**STAFF REPORT: OCTOBER 11, 2023 MEETING**

**APPLICATION NUMBER: HDC2023-00053**

**ADDRESS: 3747 TYLER**

**SCOPE: REMOVE ORIGINAL WINDOWS\* (WORK COMPLETED WITHOUT APPROVAL), INSTALL ALUMINUM-CLAD WOOD WINDOWS**

**Front Elevation**

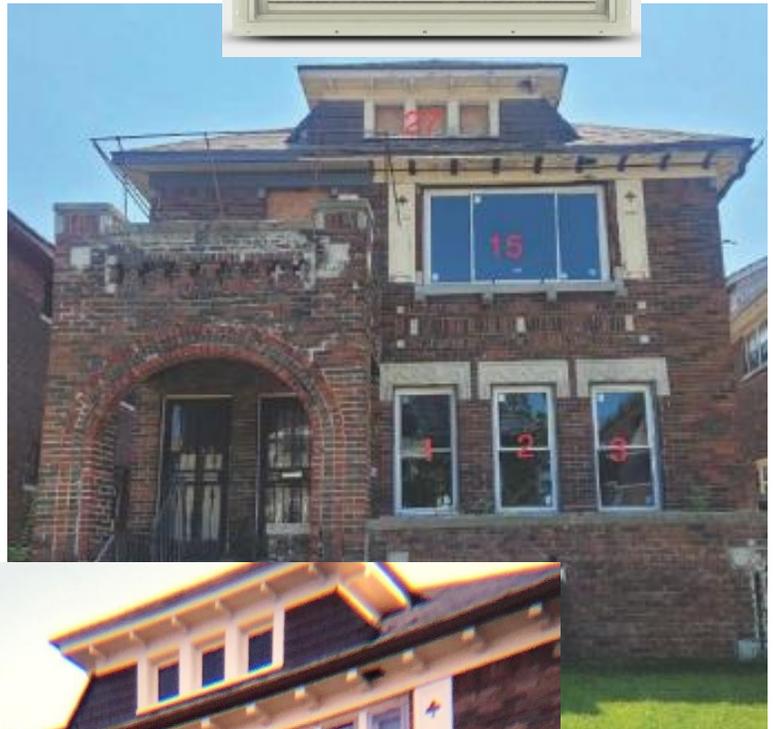
1, 2, 3 – one-over-one double-hung within each opening

*Middle - Photo from 2022 application. This view shows mullied windows in the wider than tall window openings.*

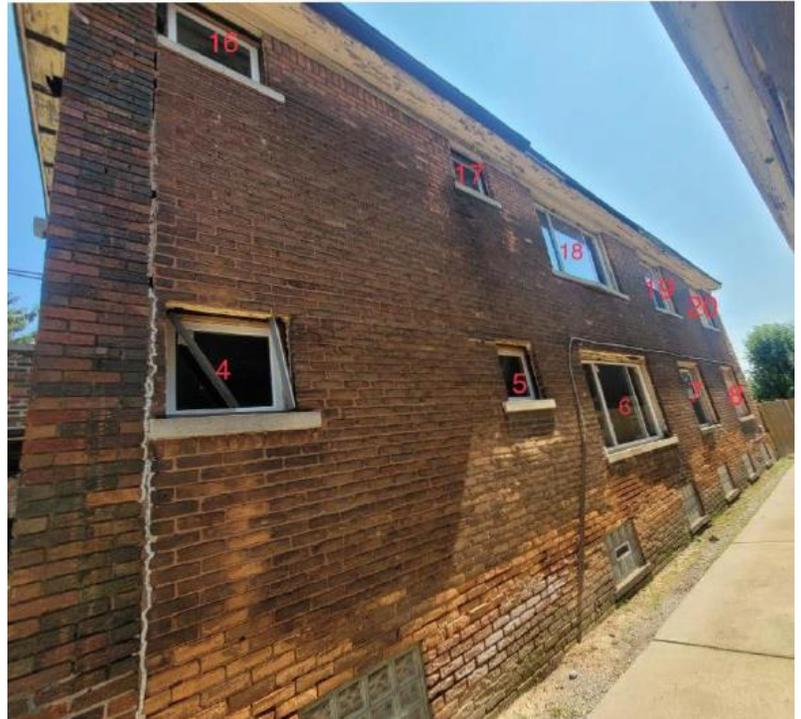
16 & 17 – one double slider within each opening. Reference photo under openings 4 & 5.

18 - One triple slider, with operating units at ends and fixed window at center. Reference photo under opening 6.

19 & 20 - One double slider in each opening. Reference photo under openings 7 & 8.

*3747 Tyler, 2018 east elevation.*

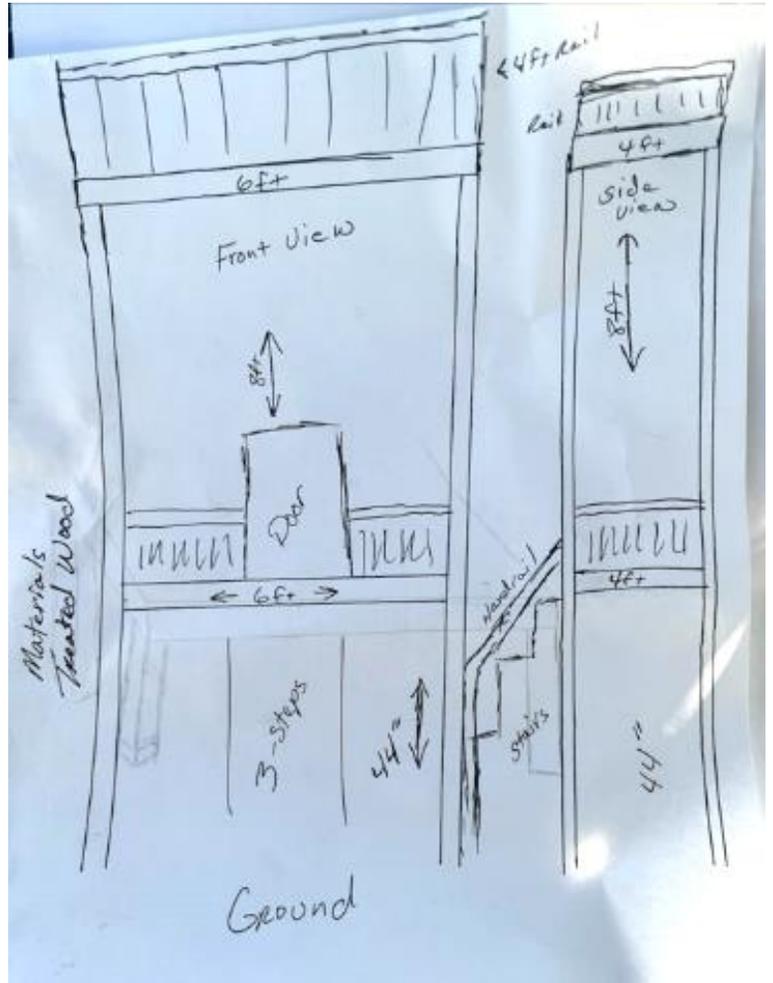
- Neither a project review request form nor a written scope of work were submitted. The applicant has not replied to staff communication requests related to this project. Staff listed the proposal scope of work based on the submitted materials.
- The 2018 east elevation photo of 3747 Tyler shows mullied units in the wider than tall window openings, the 2018 rear elevation photo of 3747 Tyler shows three-over-one double-hung units, and the 2022 photo of 3755 Tyler shows three-over-one double-hung mullied units in a similar wider than tall opening, therefore it is staff's opinion the side and rear elevation windows at 3747 were consistently three-over-one double-hung units in single and mullied window openings.

- As staff has demonstrated, the existing vinyl windows do not match the original windows in materiality, dimensionality, operation, decorative features, and color. The existing and proposed windows, in addition to the rear elevation door removal/window installation, destroyed distinctive character-defining features and substantially altered the appearance of the building. Therefore, this proposal to replace the existing vinyl units with aluminum-clad wood units that will match the operation, design and color of the existing windows does not improve the historic and architectural design of this property and should not be considered. All the windows were removed without Historic District Commission approval. Therefore, based on the Standards, new windows should match all the details of the historic windows that were removed.
